**(SECOND REBID) REROOFING OF BUILDING CARVER HALL ANNEX  
GRAMBLING STATE UNIVERSITY  
GRAMBLING, LA.  
PROJECT NO. 01-107-24-05, F.01004636**

**WHITTINGTON ARCHITECTS INC  
P.O. BOX 1701  
RUSTON, LA. 71273-1701  
318-548-2485**

**ADDENDUM NO. 1  
June 26, 2026**

ROOF EXPANSION JOINT DETAIL  
N.T.S.

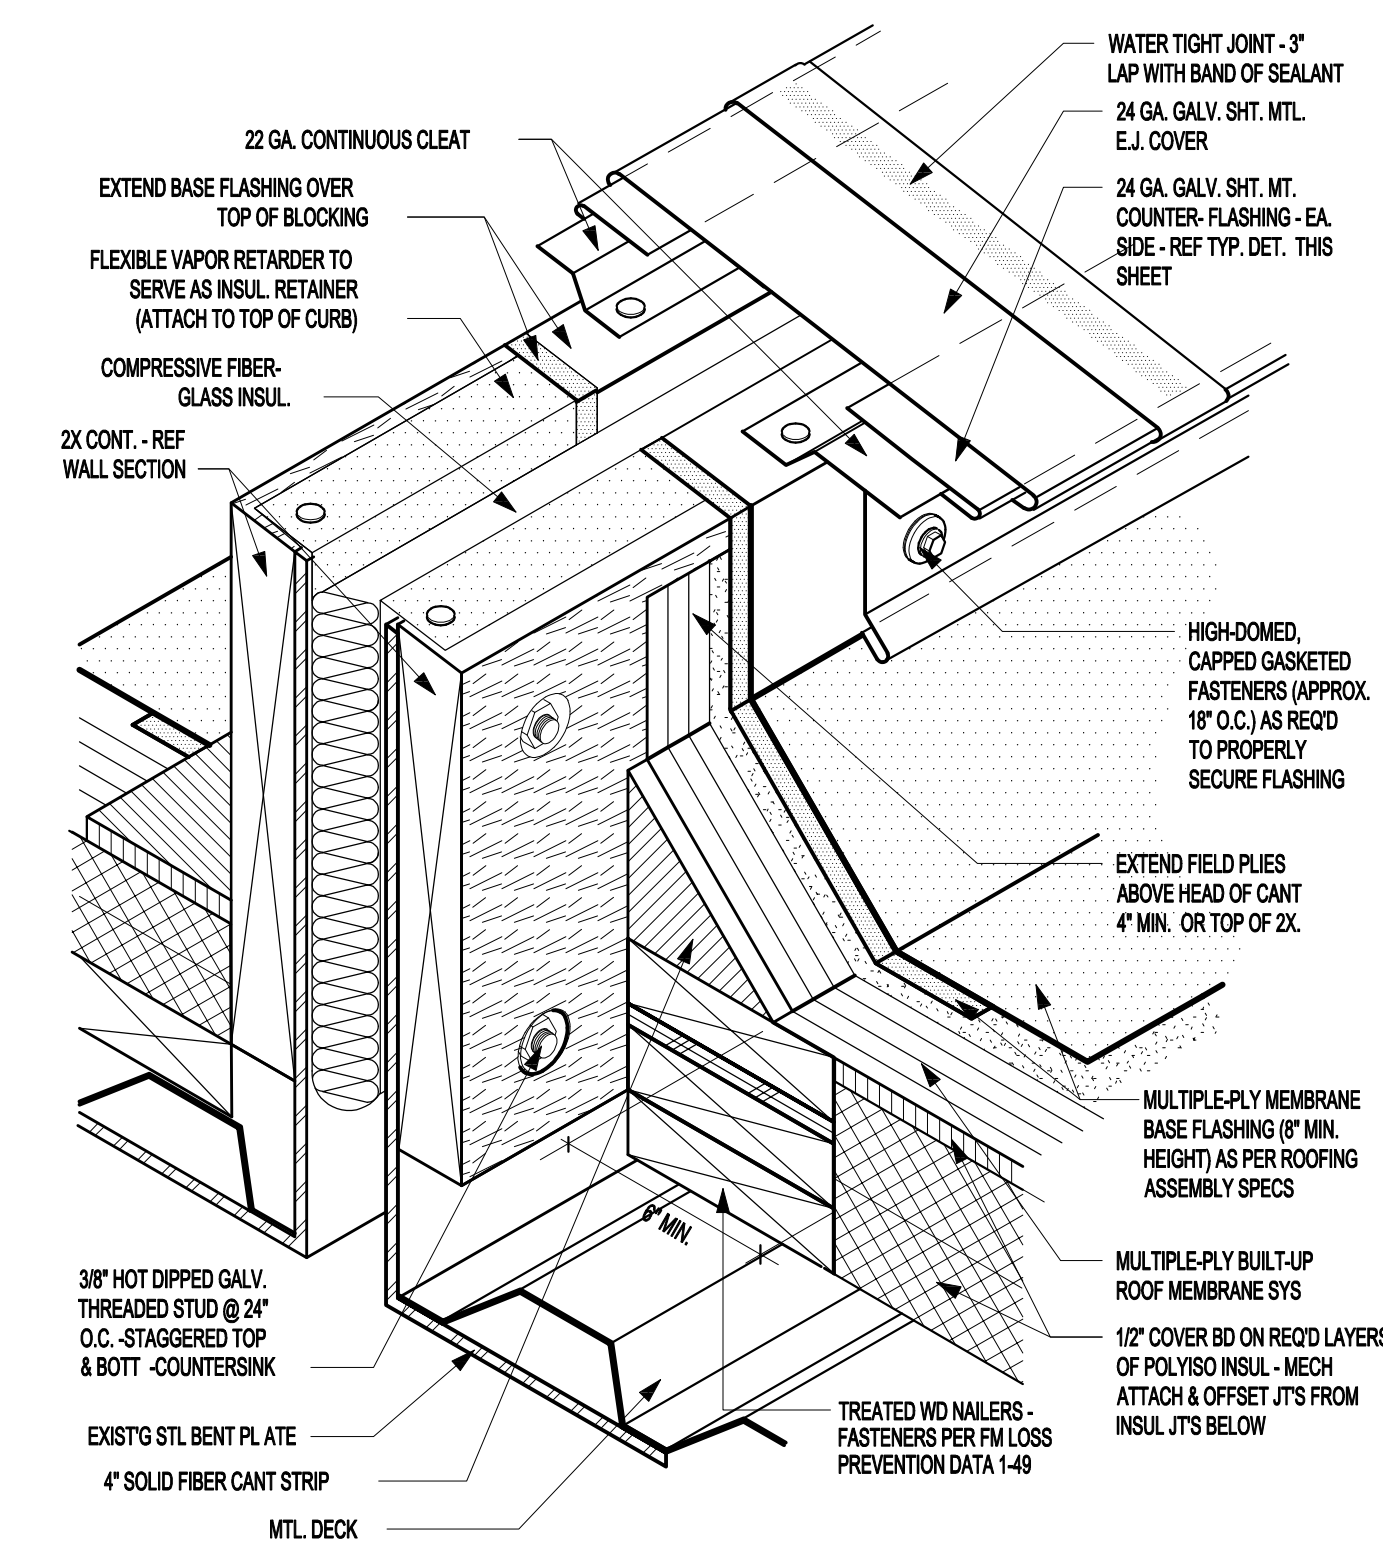
**ITEM NO. 4:** Existing **gutters and downspouts** to remain. New **coping** shall be provided where existing on lower roofs and expansion joints. Match existing in style, color and as detailed.
